UNITED STATES PATENT AND TRADEMARK OFFICE

APPLICATION NO.	FILING DATE	FIRST NAMED INVENTOR	ATTORNEY DOCKET NO.	CONFIRMATION NO.
10/763,070	01/22/2004	Jean-Luc Morand	S1022.81118US00	3710
23628	7590	12/29/2005	EXAMINER	
WOLF GREENFIELD & SACKS, PC FEDERAL RESERVE PLAZA 600 ATLANTIC AVENUE BOSTON, MA 02210-2211			NGUYEN, THINH T	
			ART UNIT	PAPER NUMBER
			2818

Office Action Summary

DETAILED ACTION

Fig. 3

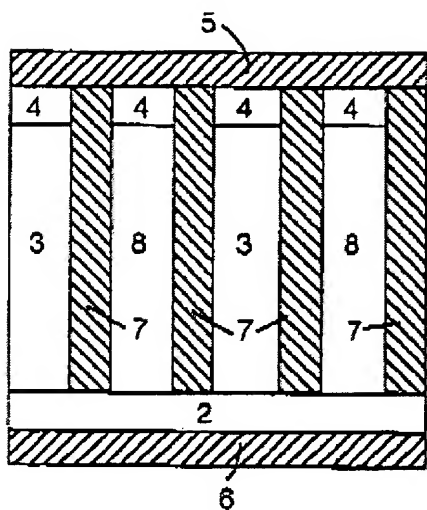
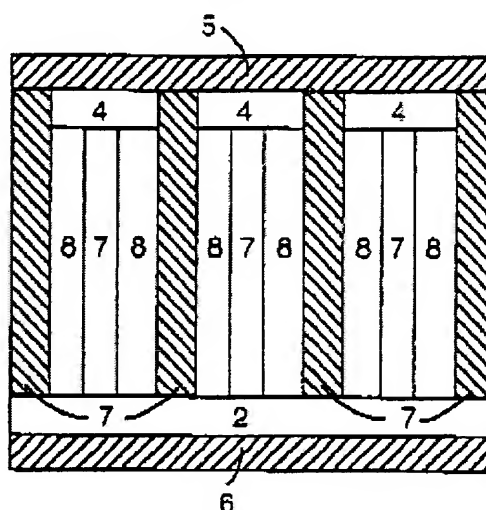
Pfirsch (in fig 3, fig 6,fig 7, column 2 lines 35-44,column 6 lines 42-51) discloses

A semiconductor component in which the active junctions extend perpendicularly to a first surface of a semiconductor chip substantially across an entire thickness thereof, wherein the semiconductor chip has a first metallization associated with the first surface and a second metallization associated with a second surface, the first and second surfaces being on opposing sides of the semiconductor chip.

Noted that electrodes 5 and 6 in Pfirsch disclosure can be aluminum (Column 6 lines 42-51 of the Pfirsch reference) therefore they are inherently metallization layers.

FIG. 2

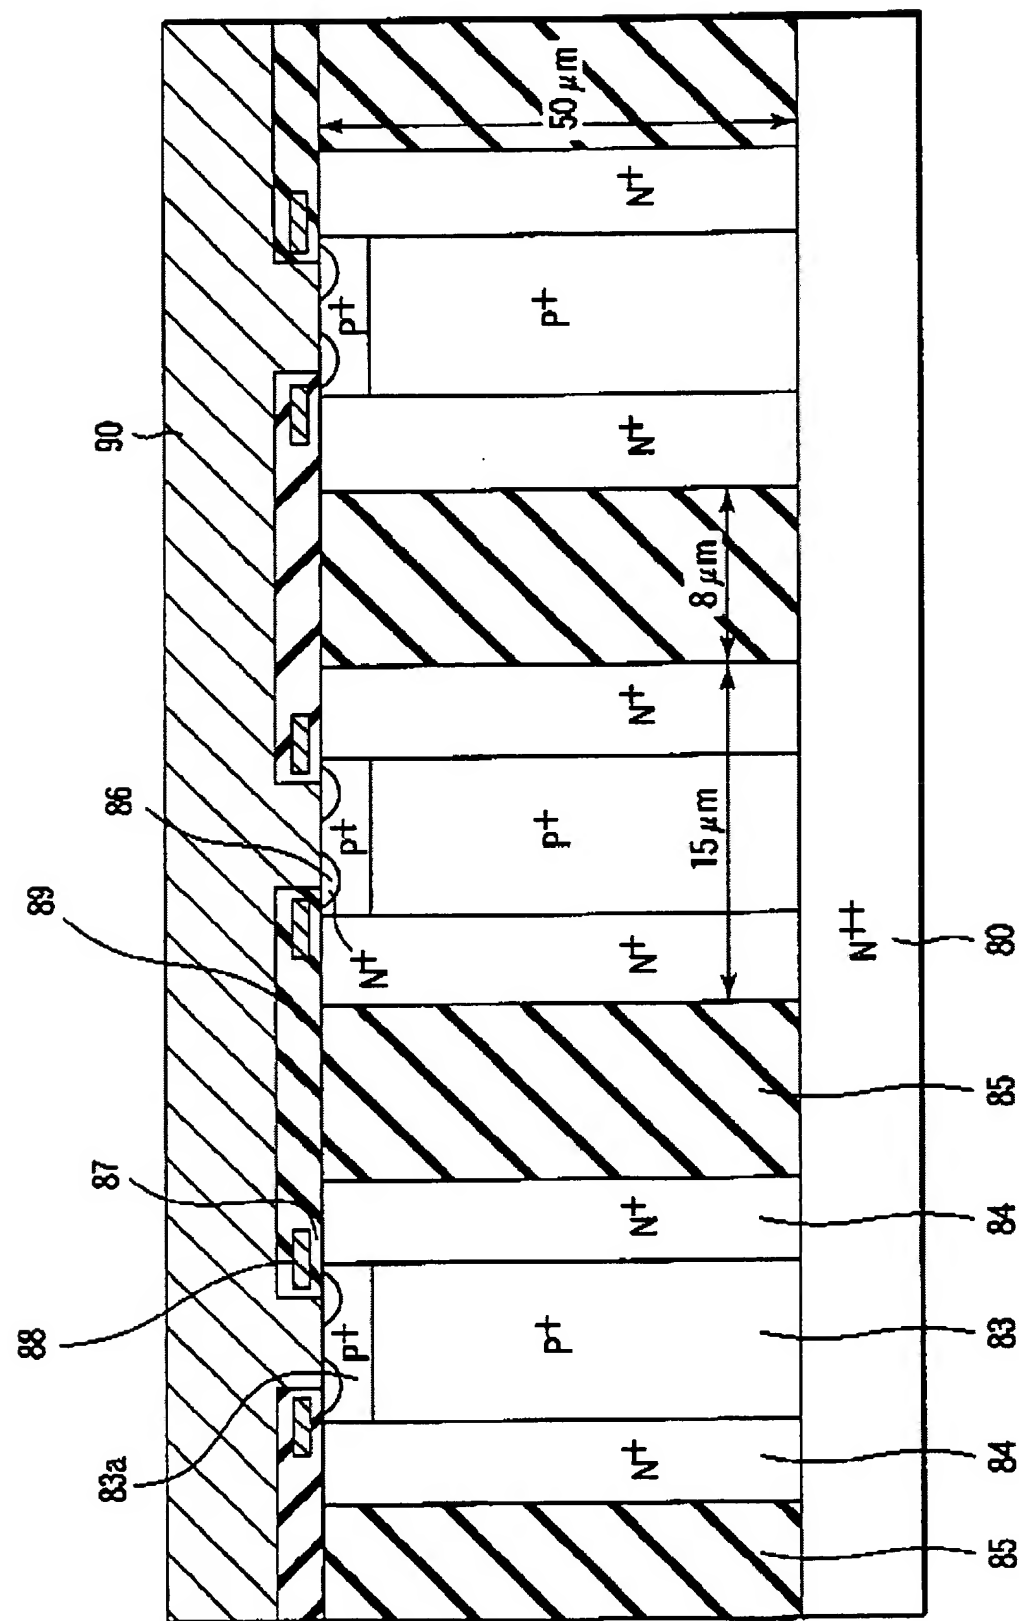
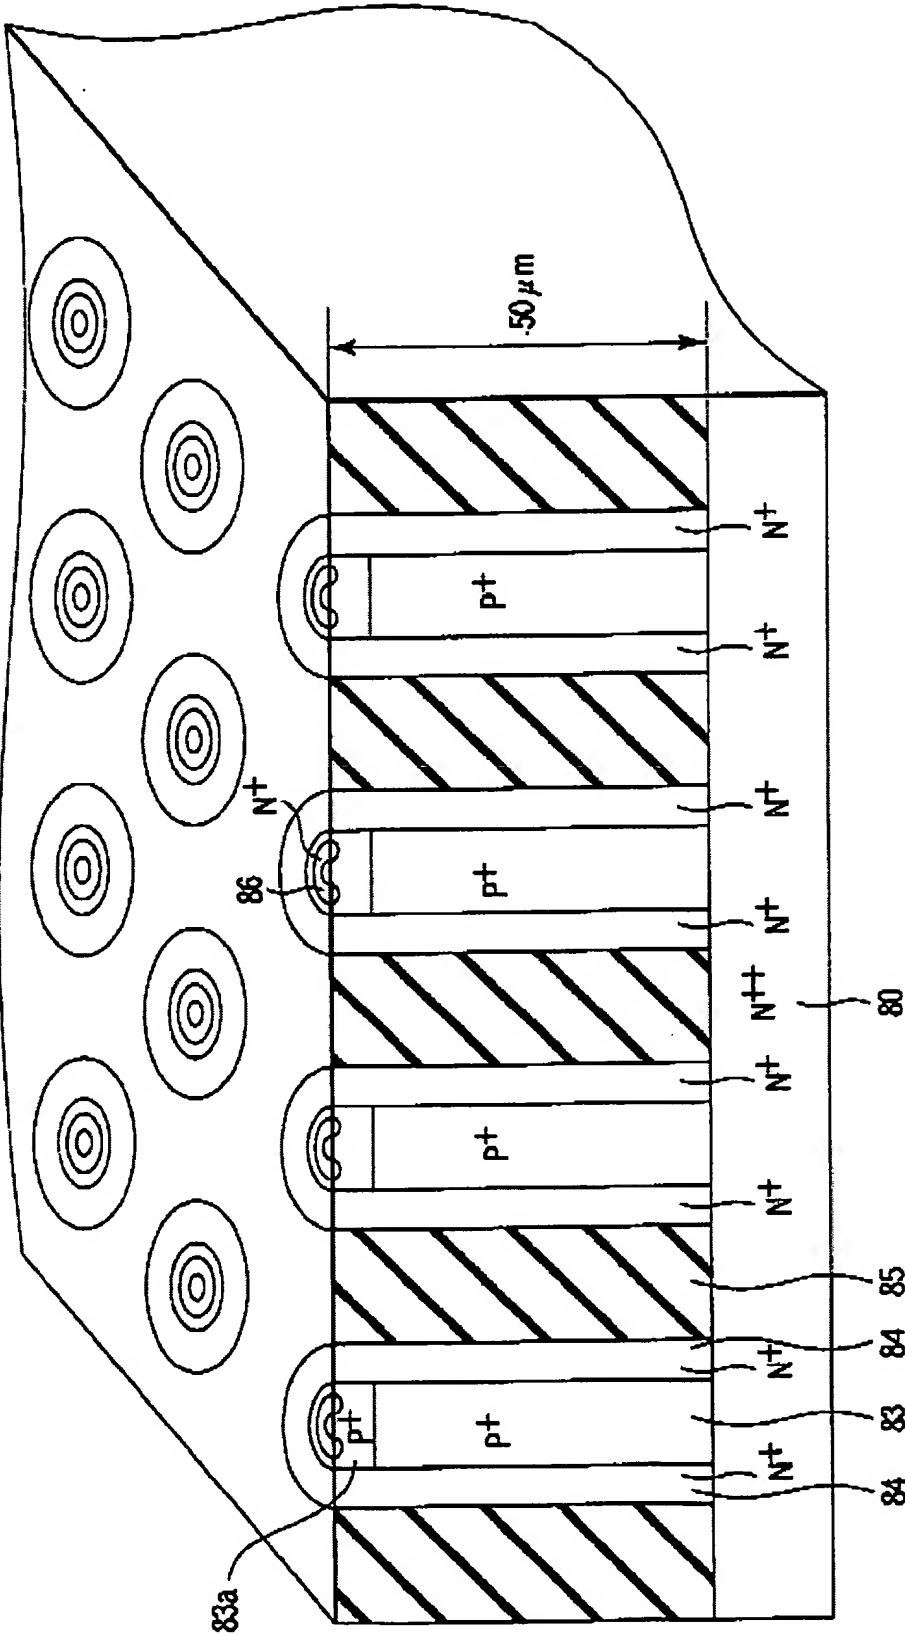
Usui (the abstract, in fig 2, fig 4) discloses all the invention of a semiconductor component in which the active junctions extend perpendicularly to a first surface of a semiconductor chip substantially across an entire thickness thereof wherein the semiconductor chip has a first metallization associated with the first surface (column 5 line 7 source metal wiring 90) wherein the contacts with the regions to be connected are provided by conductive fingers (see fig 4) substantially crossing an entire region with which a contact is desired to be established.

Missing in Usui reference is a metallization contact of the drain layer, this feature however is considered obvious because the metallization of the drain layer is old and well known in the art as evidenced by the disclosure by Hurkx et al. (US patent 6,624,472) in column 6 lines 49-50 in fig 1 layer 15,16.

FIG. 4

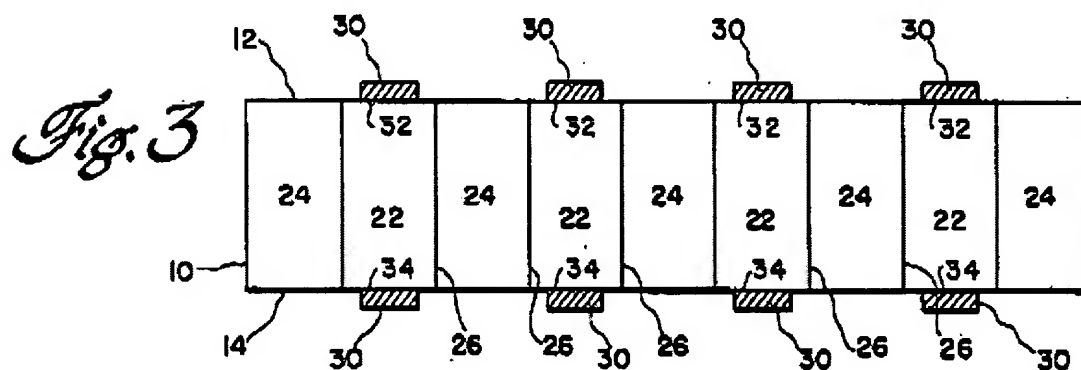
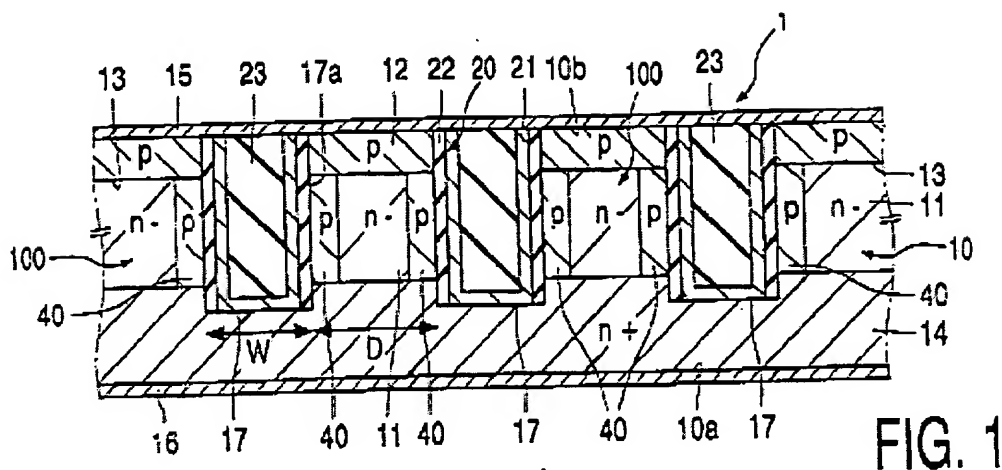
Usui (in fig 4) disclose a multi-cellular semiconductor wherein the junction are formed of several cylinders perpendicular to the first surface.

As discussed in the rejection of claim 1, Pfirsch discloses all the invention including the structure of a diode (column 4 line 7). Missing in Pfirsch disclosure is the uses of conductive fingers. Usui, however, (in fig 4) discloses the use of conductive fingers.

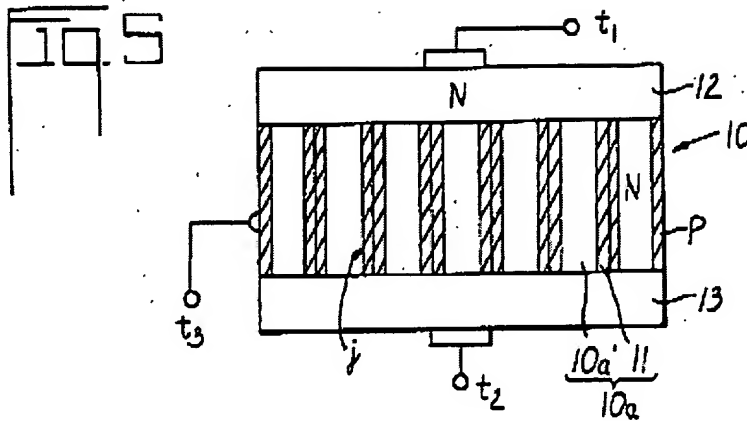
Rouse (fig 5,claim 2) disclose all the invention including a transistor device (see claim 2) except for the use of conductive fingers on all three transistor terminals. Kobayashi et al., (fig. 5), however teach how to connect conductive fingers to a three terminal devices.

Noted that Kobayashi has terminal T1 and T2 that can be metallized.

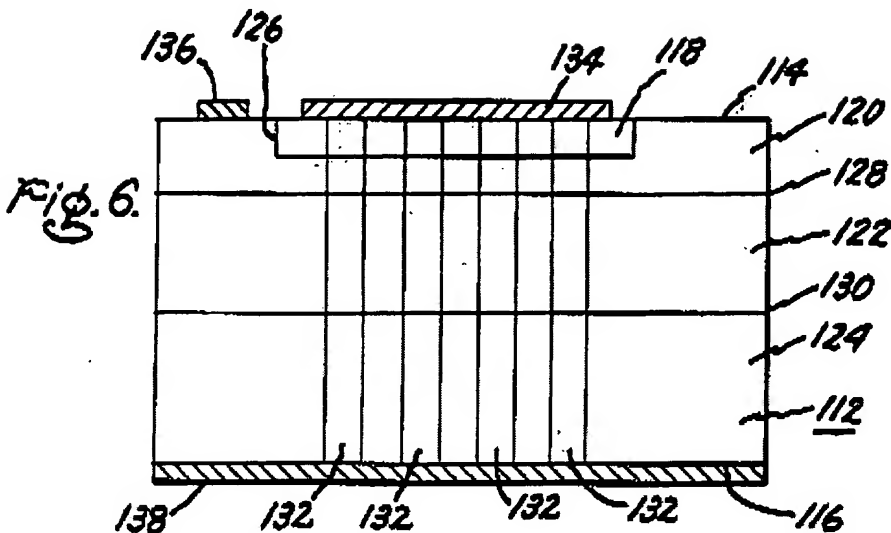
Krishna (fig 6) disclose all the invention including a thyristor device (column 1 line 14) except for the use of conductive fingers on all three thyristor terminals. Kobayashi et al., (fig. 5), however teach how to connect conductive fingers to a three terminal devices.

Noted that Krishna discloses in fig 6 a device that can has electrode layer 134, 116 On the opposite sides of the semiconductor device metallized.
